AGENDA

City of Hapeville

Design Review Committee

October 16, 2019

LEFT ELEVATION

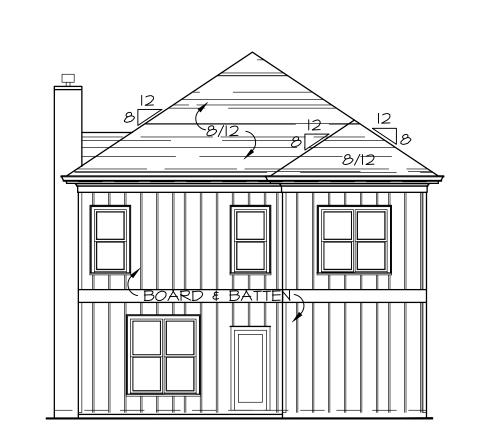
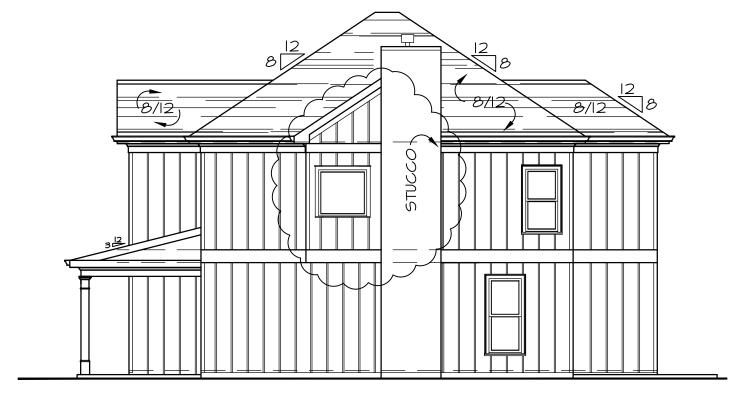
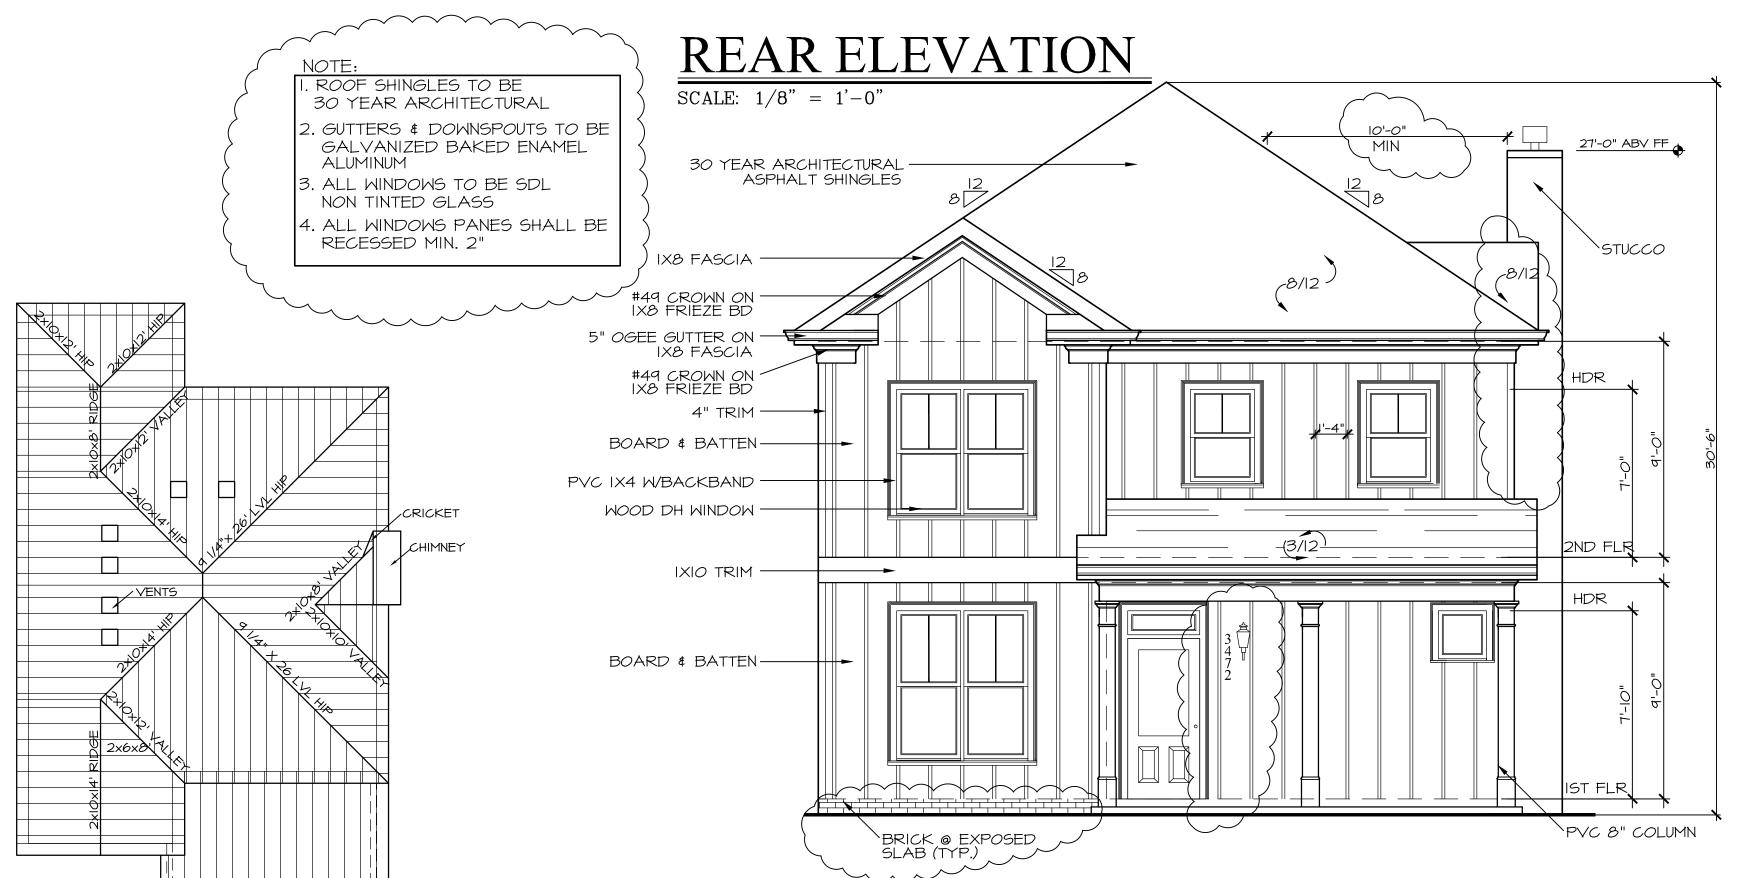
Change window grille pattern from 2 over one to four over four Add angle brace detail to columns
Add bracket and corbel trim to soffit

Site Plan

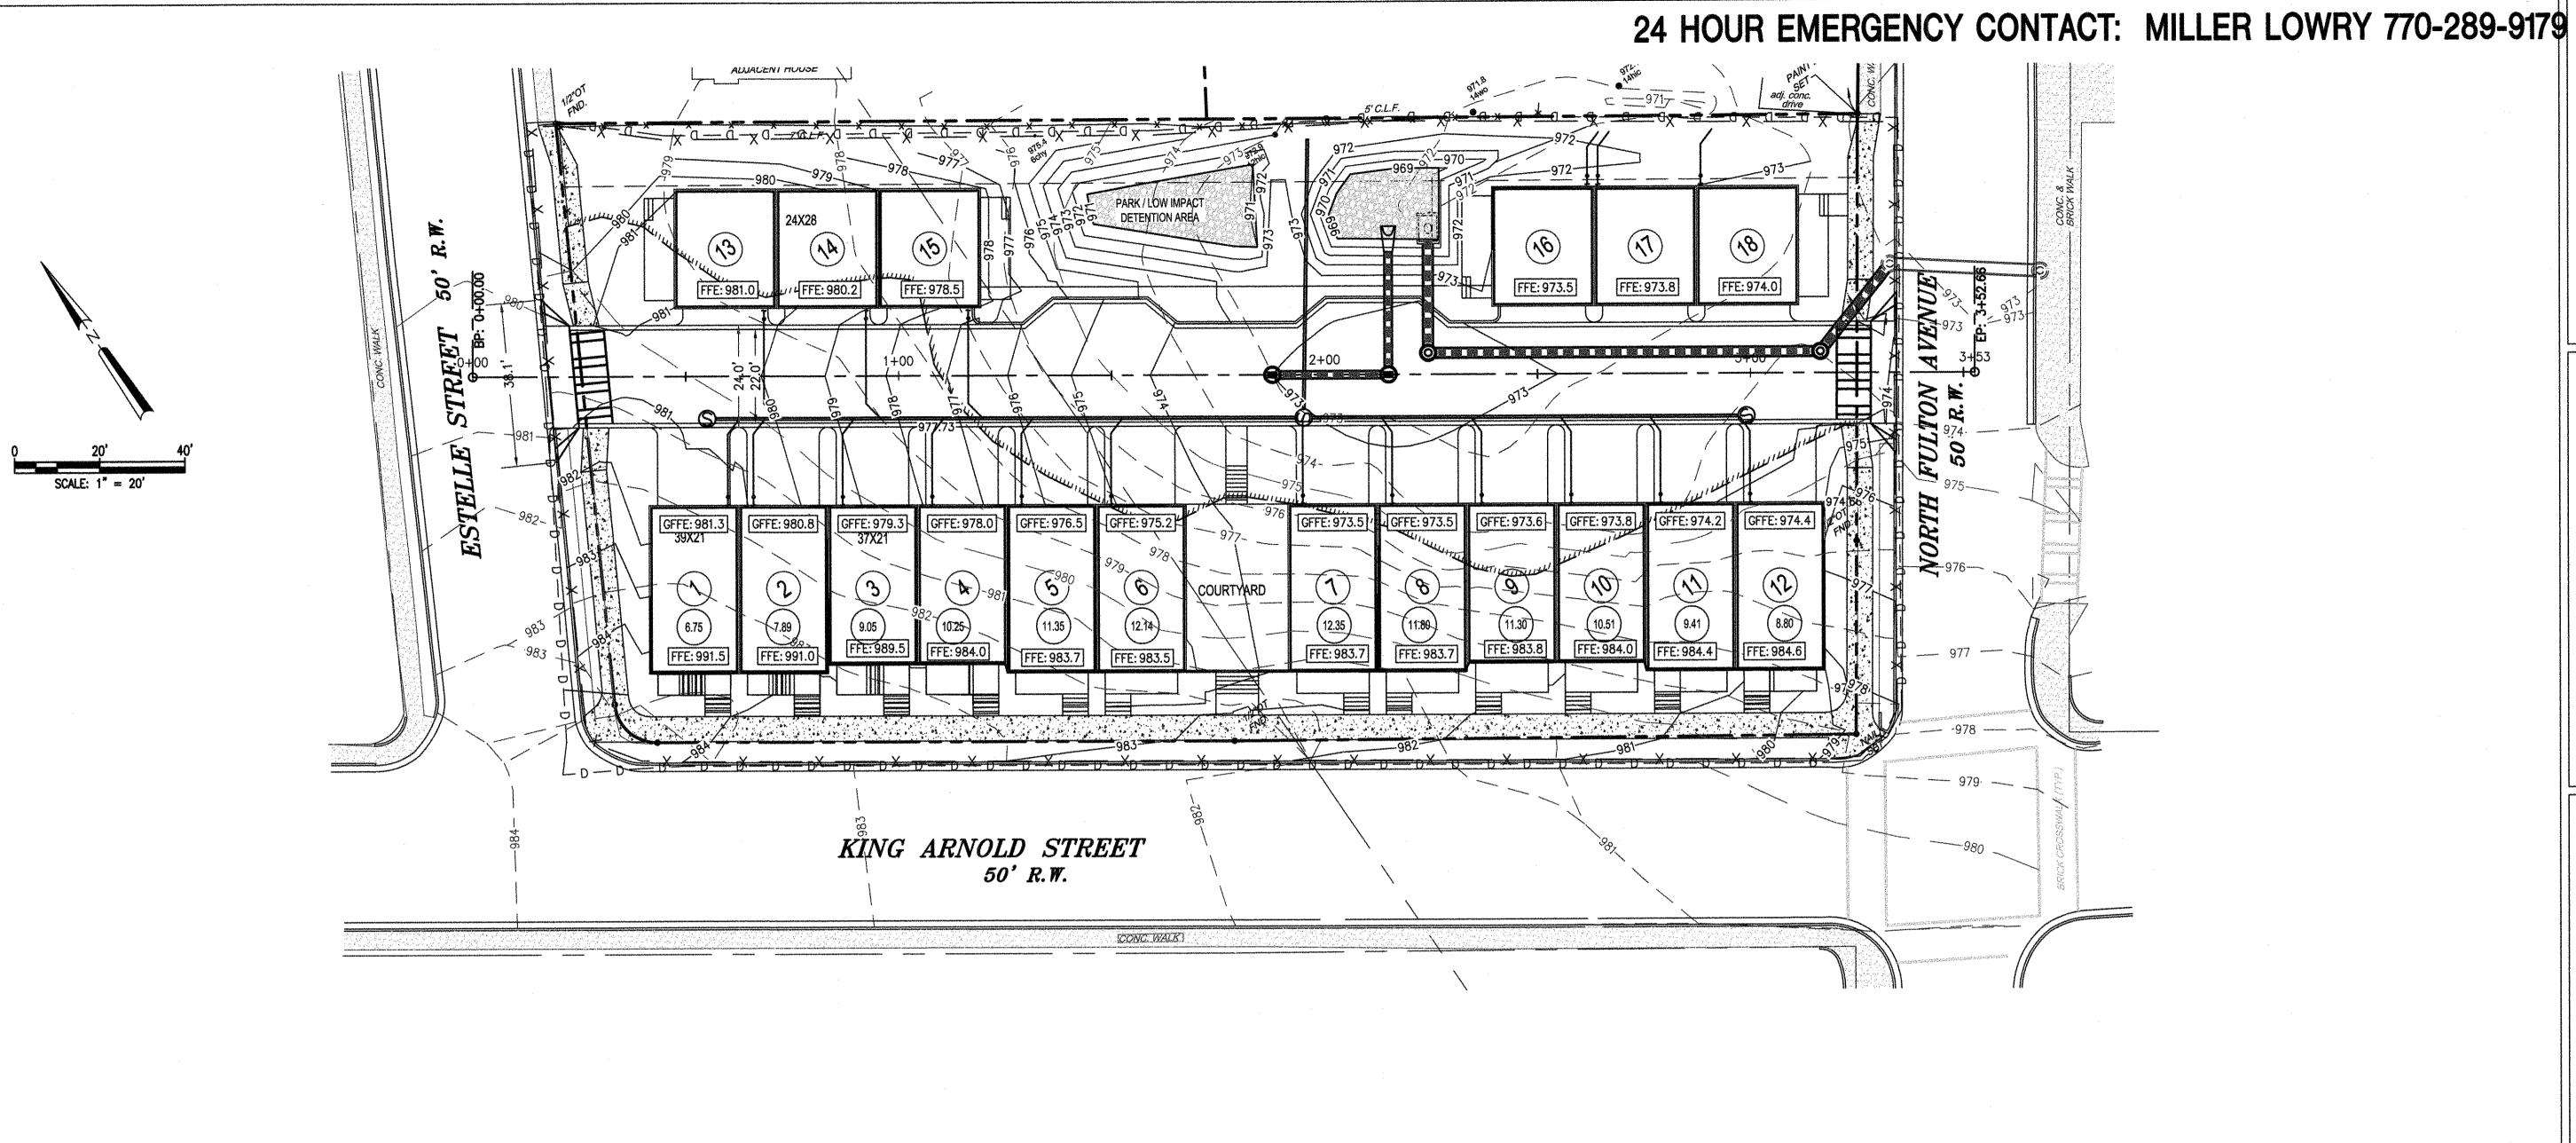
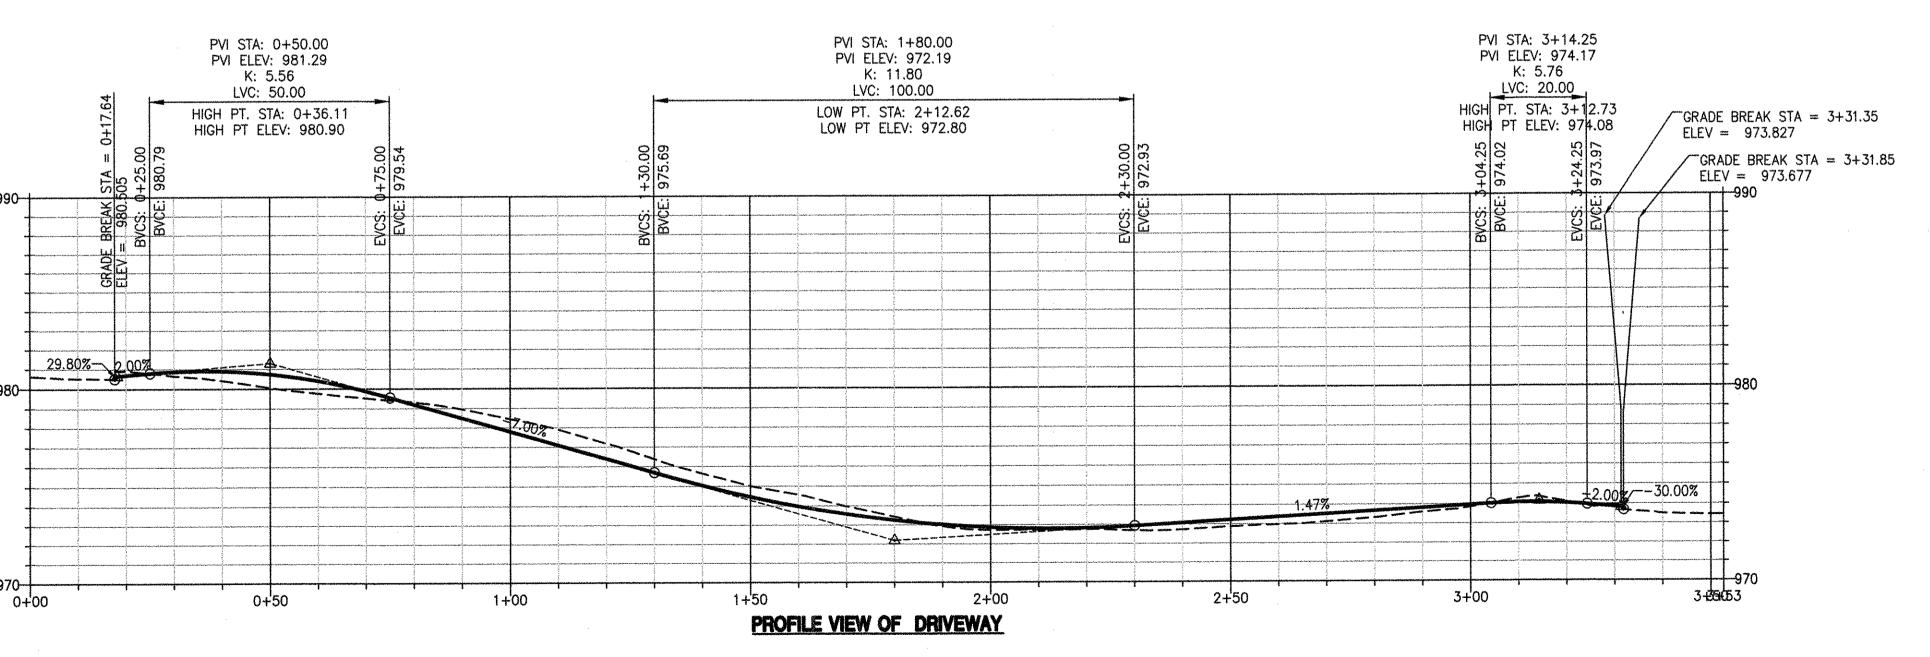
4. Street trees must be planted a maximum of 40' on center in the landscape area of the sidewalk. Street trees are proposed along King Arnold but the spacing has not been provided. No street trees have been proposed along Estelle and North Fulton, which is not compliant. **The applicant must plant the required street trees and show required spacing on plans.** This is also required by U-V zoning.

5. Fences, walls, or hedges are encouraged by the architectural design standards and are required by U-V zoning along the sidewalks adjacent to the alley. The applicant must add required fences, walls, or hedges to the plans.

13. The entrances for buildings 14-17 do not face, are not visible from, are not accessible from, and are not connected by a walkway to the adjacent public sidewalk, which is not compliant with the architectural design standards or with A-D overlay zoning. The applicant is seeking a Variance from the Board of Appeals for the latter. Regardless of the outcome, the applicant will need to revise the plans to have all buildings front on public streets or receive a design exception.

The plans show fences and walls along King Arnold, and hedges along the two side streets, which is compliant.

In addition, the plans now show a sidewalk wrapping around units 13-18, similar to what was suggested by the Design Review Committee.

1 ELEVATION - KING ARNOLD STREET

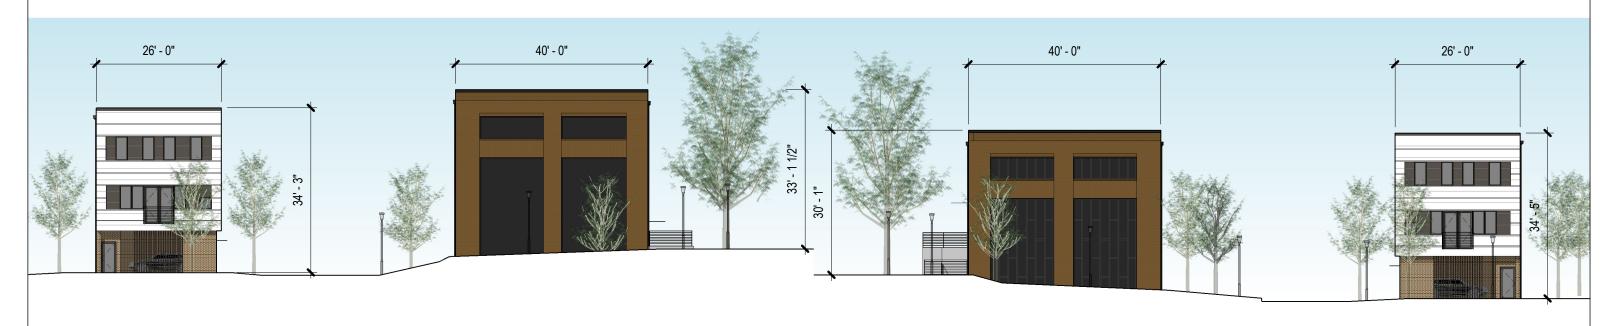
12. Building numbers are shown on renderings but not on elevations. The plans should be revised to show building numbers on the elevations.
